**IN THE MATTER OF APPLICATION
FOR TRANSFER NOS. 84488 AND
84490 IN THE NAME OF LCSC
ENTERPRISES LLC**

**SURFACE WATER COALITION'S
NOTICE OF SERVICE OF REBUTTAL
EXPERT REPORT**

LCSC Transfer Applications 84488 and 84490 SWC Rebuttal Report

FIGURE 1
GEOLOGIC MAP AND
CROSS SECTION LOCATION
NEAR LCSC PROPOSED PODS

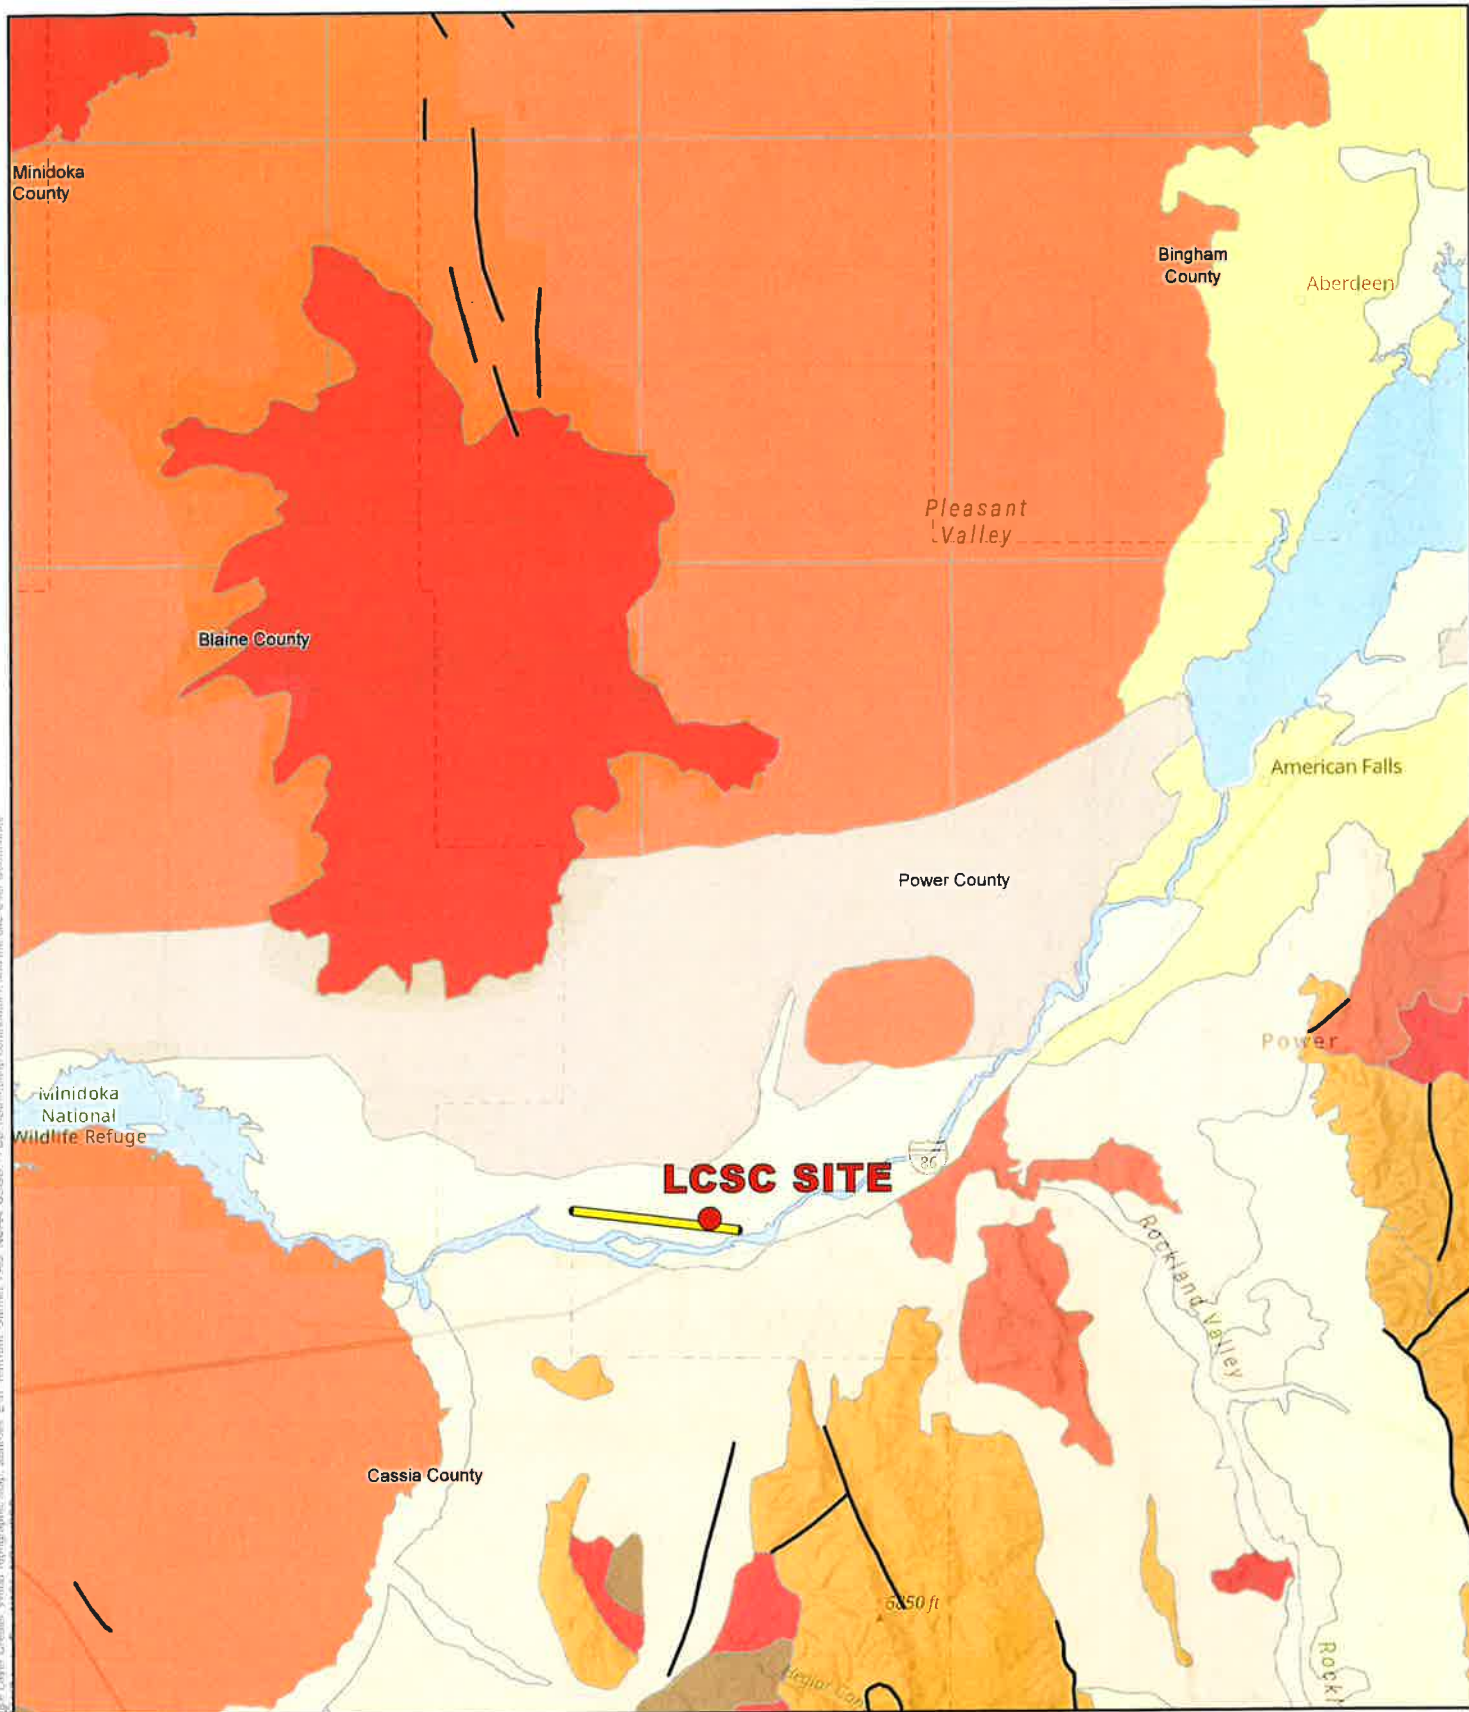
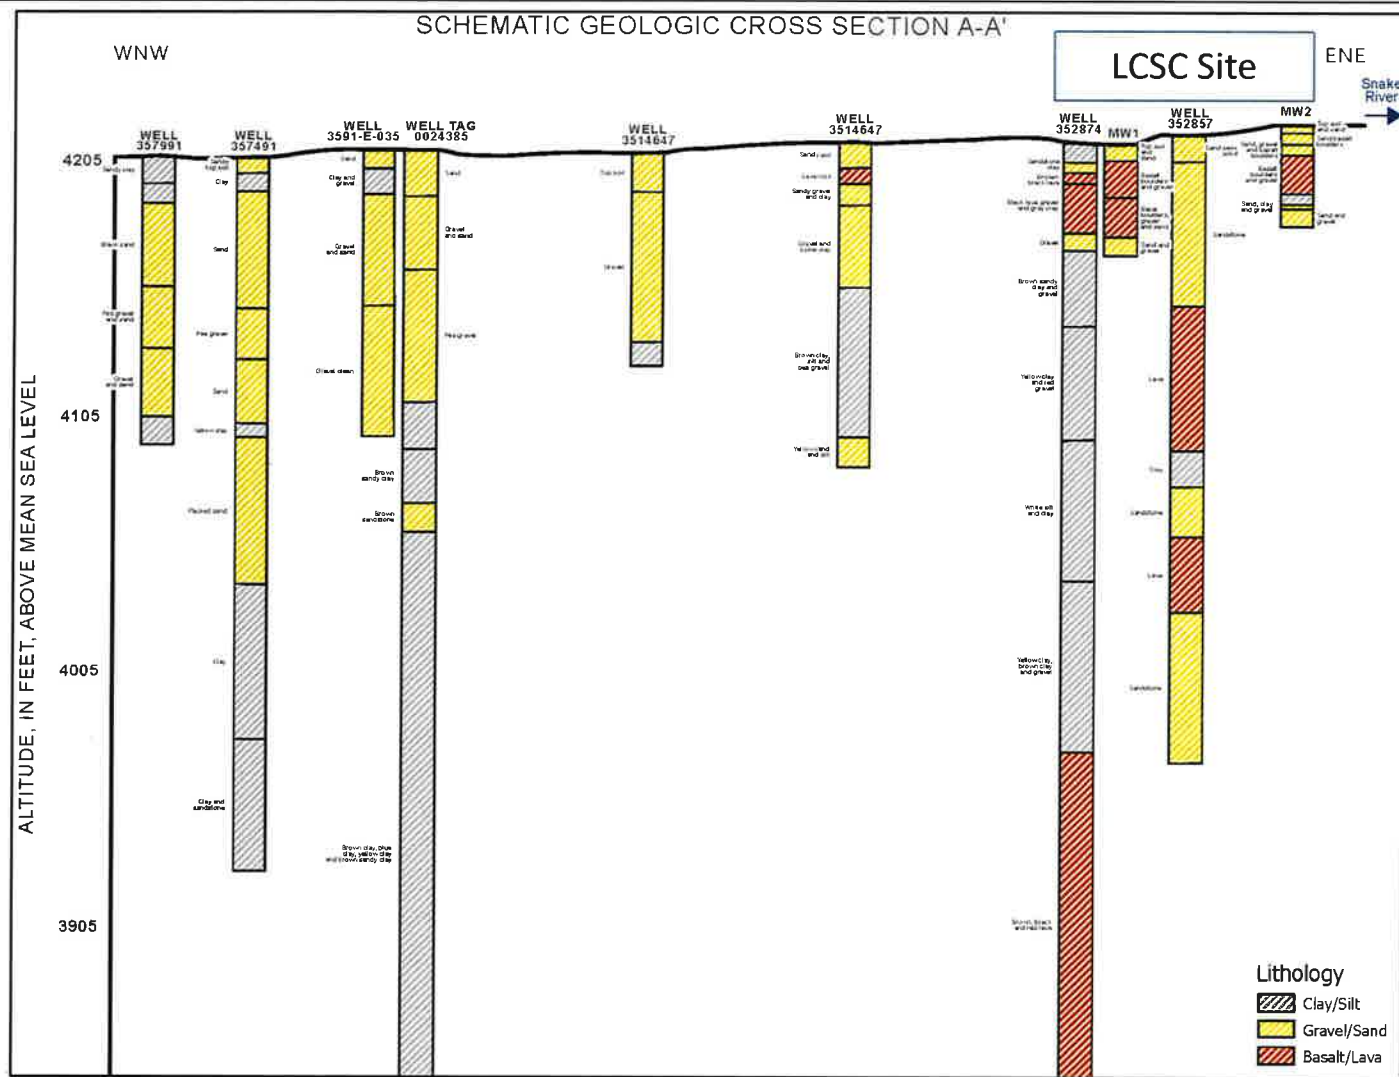
with significant local heterogeneity in permeability and aquifer connectivity. We evaluated driller's logs for nearby wells and created a cross section shown below in Figure 1 and Figure 2.

Figure 1 shows significant geologic heterogeneity near the proposed LCSC transfer site.

The cross section shows significant variability in lithology near the proposed PODs and no clear evidence of a laterally contiguous impermeable layer separating shallow and deep aquifer materials. The LCSC transfer site includes Well 352874, MW-1, MW-2, and Well 352857. The lithology reported in Well 352857 is significantly different from Well 352874, with only a thin clay interval reported. This lithology does not support the theory that a thick, laterally continuous clay layer disconnects the deeper basalt aquifer from the Snake River.

The regional geologic framework also shows several mapped faults near the site, including the Great Rift Zone to the north of the proposed PODs and additional structures to the south of the Snake River (Figure 1). These faults may influence groundwater flow patterns in the area. Fault zones often exhibit enhanced fracturing and increased secondary permeability, which can create vertical pathways through otherwise low-permeability layers.

- **Opinion 10** – Geologic evidence does not support the theory that a laterally continuous impermeable layer vertically separates Snake River impacts from pumping proposed PODs.

Figure 3
Water Level Elevations in MW-1, MW-2
and Well 352874 (adapted from
Clearwater Geoscience, LLP, 2024)

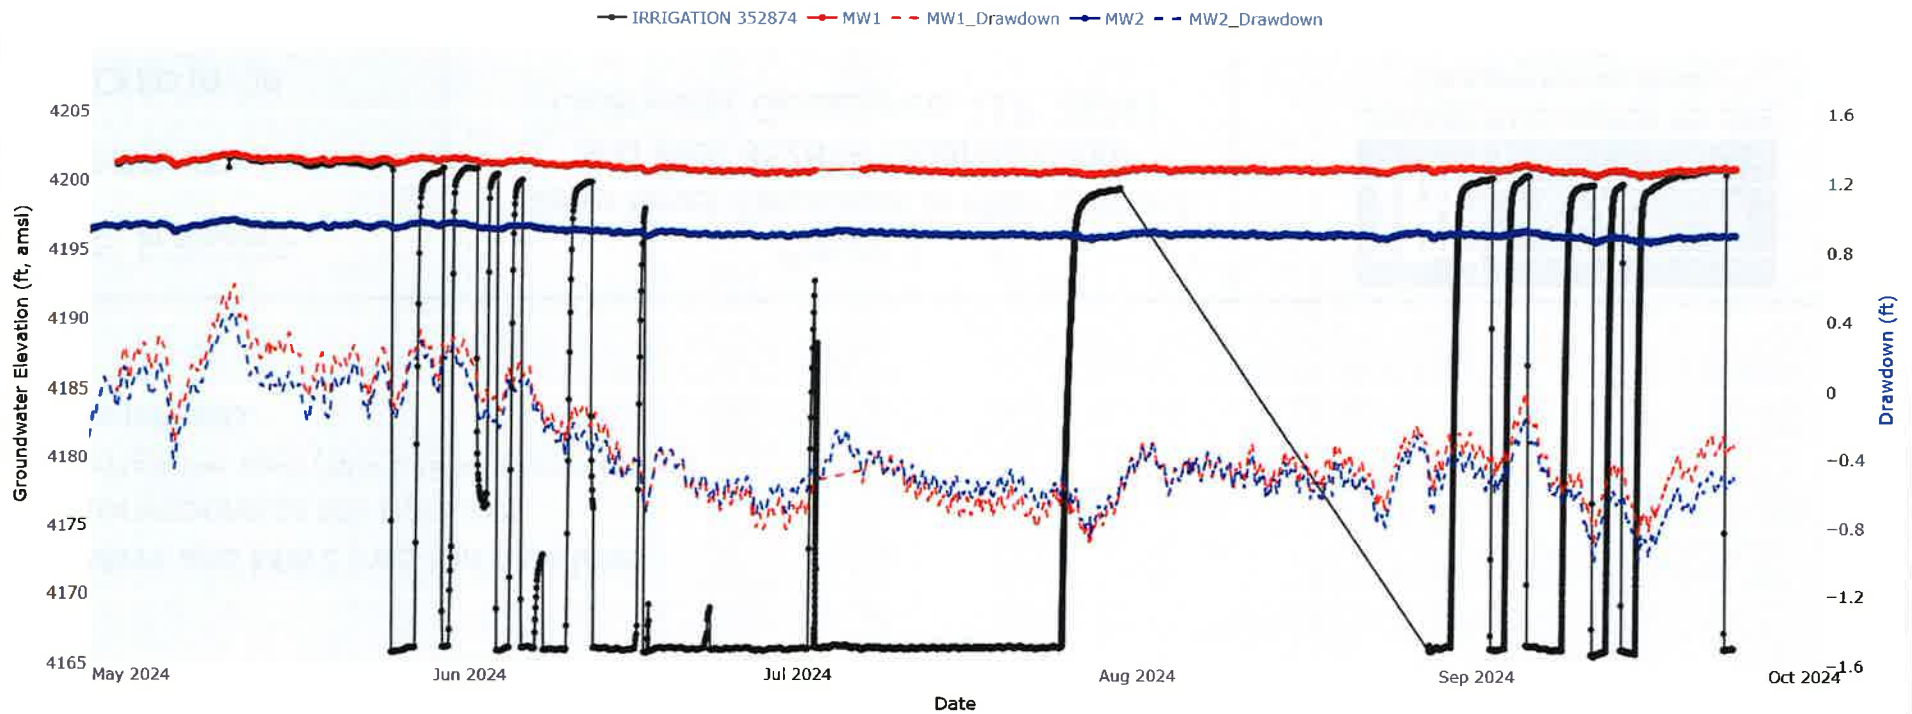
Clearwater plotted all the water level data on one scale, which obscures the changes in MW-1 and MW-2 water levels. In their graph, water levels in MW-1 and MW-2 appear generally stable during the monitoring period. However, when the water level data are plotted on separate scales with MW-1 and MW-2 as drawdown, fluctuations are visible during periods that correspond with deep well pumping (Figure 4). These are most apparent in late May, late July, and early to mid-September.

Figure 4
Water Level Data Plotted On Multiple
Scales

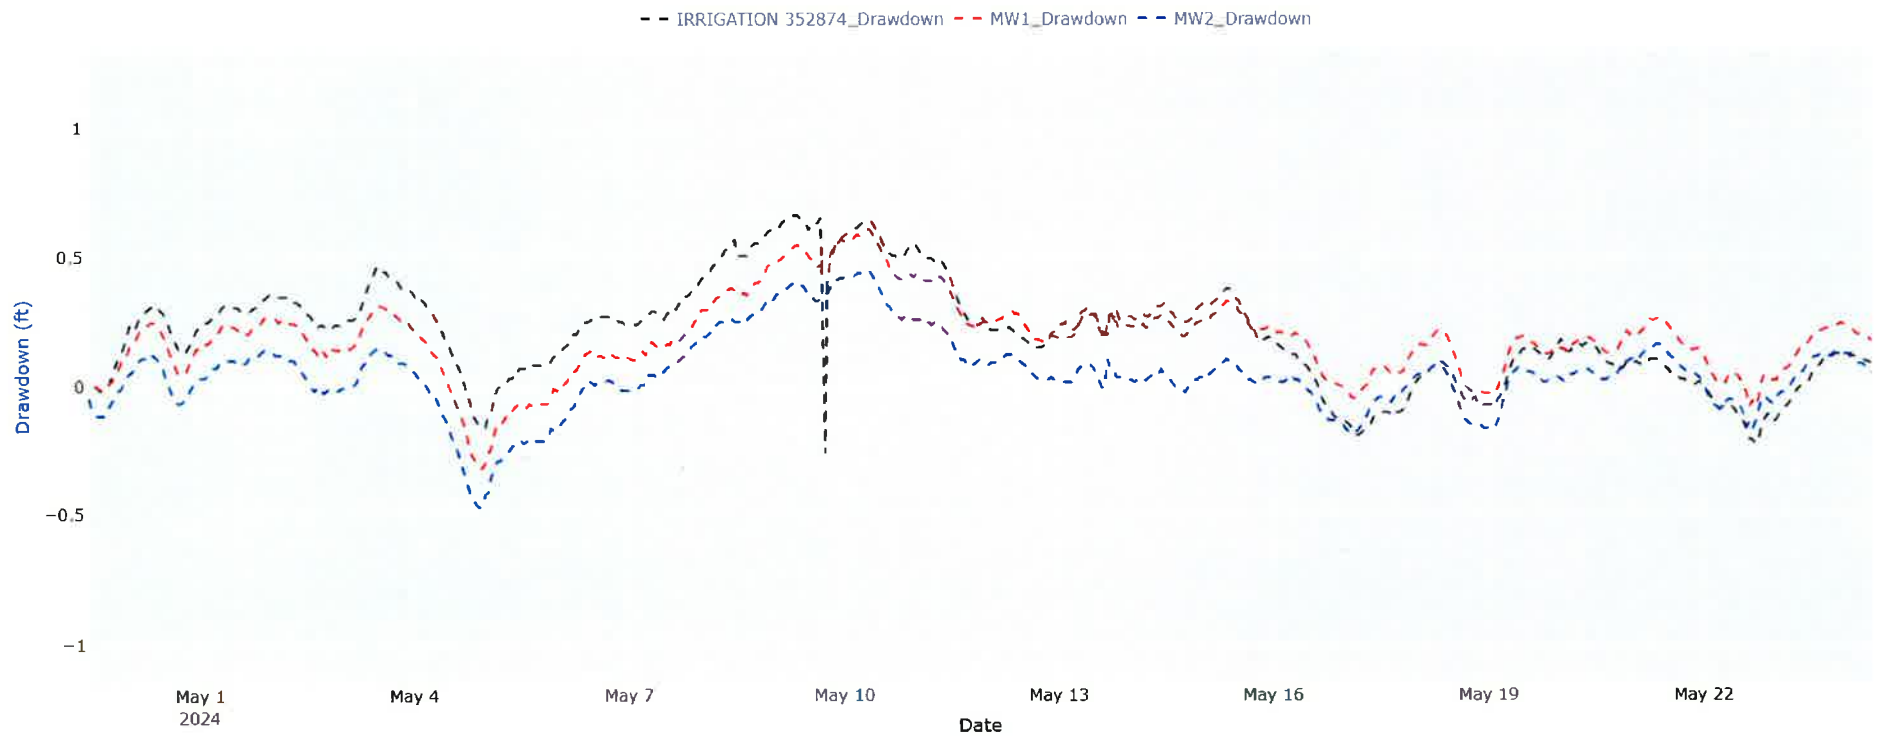
The timing and shape of these changes in shallow water levels suggest a measurable hydraulic response to deep aquifer pumping. The response repeats during multiple pumping and recovery events, supporting the possibility of vertical connectivity between the aquifers. These data do not support Clearwater's theory that the pumping of Well 352874 is disconnected from the Snake River.
